ABOVE APPLIES TO MODELS:

ALL FORD V-8

18-12116—Terminal Plate
Fig. 4

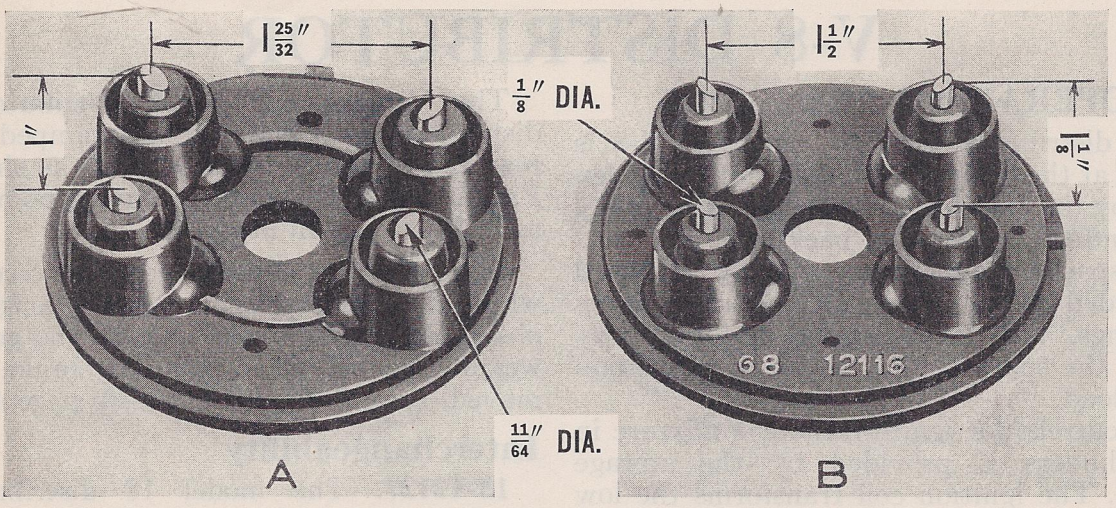
nal plates (see Figs. 4 and 5) and caps, as these parts are not interchangeable on these distributors. This distributor can be used to replace the 78-12127 distributor except it will be necessary to change coil and condenser.

40-12127-B—Distributor
Fig. 6

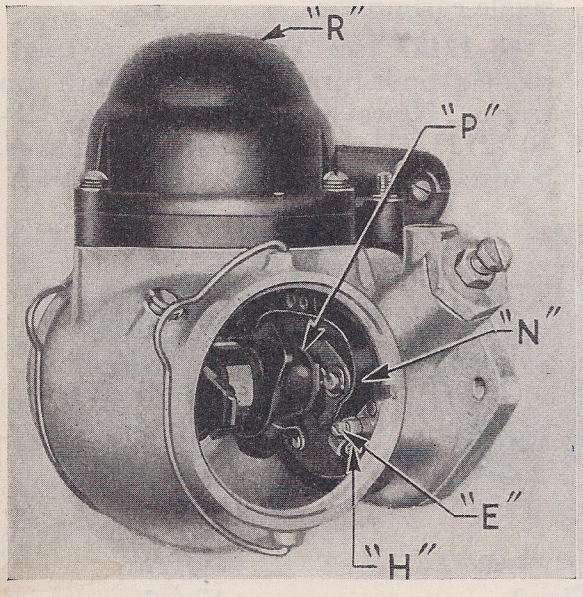
78-12127 can be used on all models, both cars and trucks except that in replacing distributors prior to 68-12127 it is necessary to likewise change the coil, condenser, terminal plates and caps. When replacing the 68-12127 distributor it will be necessary to likewise change the coil and condenser.
